Groundwater Application Review Summary Form

Application # G- 19055

GW Reviewer Joe Kemper Date Review Completed: 1/8/2024

TO: Water Rights Section Date 1/8/2024
 FROM: Groundwater Section Joe Kemper
Reviewer's Name
 SUBJECT: Application G- 19055 Supersedes review of 7/14/2021
Date of Review(s)

Well Location Map

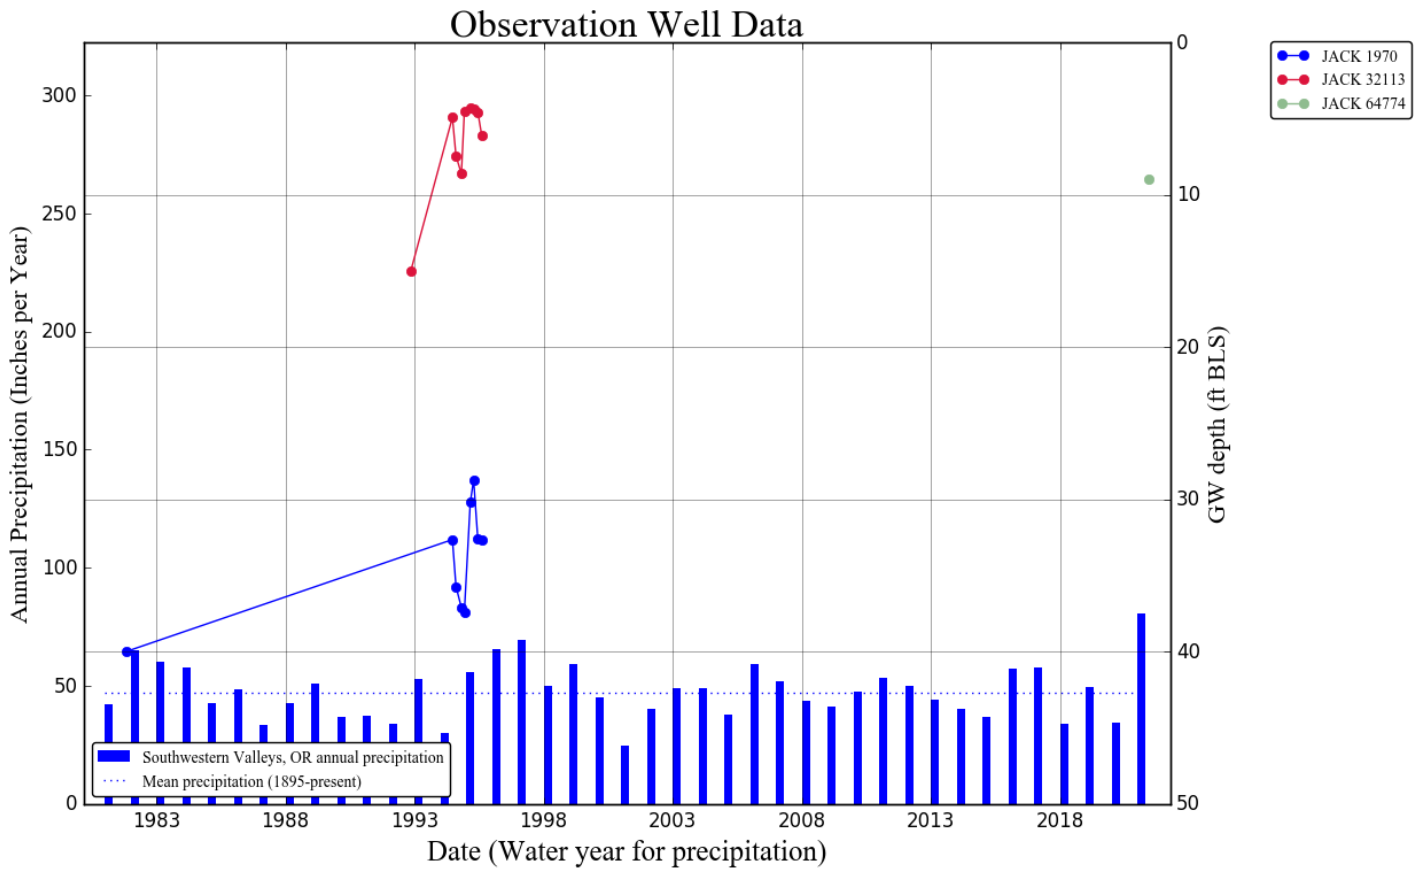
Basis for aquifer hydraulic connection evaluation: Groundwater levels in fractured rock aquifers are typically shallow. The high relief topography surrounding the applicant’s well creates a hydraulic gradient for groundwater to flow towards and discharge to surface water. The applicant’s well would access an unconfined aquifer and is located within ¼ mile of Pleasant Creek. As per OAR 690-009-0040(2), the well is assumed to be hydraulically connected to Thompson Creek.

C6. **SW / GW Remarks and Conditions:** The applicant's well accesses an aquifer that is determined to be hydraulically connected to Pleasant Creek. The proposed use is found to have the Potential for Substantial Interference (PSI) with Pleasant Creek by the following metrics as outlined in OAR 690-009: the well is located within ¼ mile of a surface water source, the requested rate (0.056 cfs) is larger than 1% of the expected natural stream flow (1% of 0.35 cfs or 0.0035 cfs), the requested rate (0.056 cfs) is larger than 1% of adopted instream flow (1% of 0.52 cfs or 0.0052 cfs), and the estimated stream depletion after 30 days is greater than 25%. A lower rate will not avoid a finding of PSI. Additionally, there are several recently constructed water wells on the applicant's property. It is noted that all of these wells appear to be located within ¼ mile of Pleasant Creek.
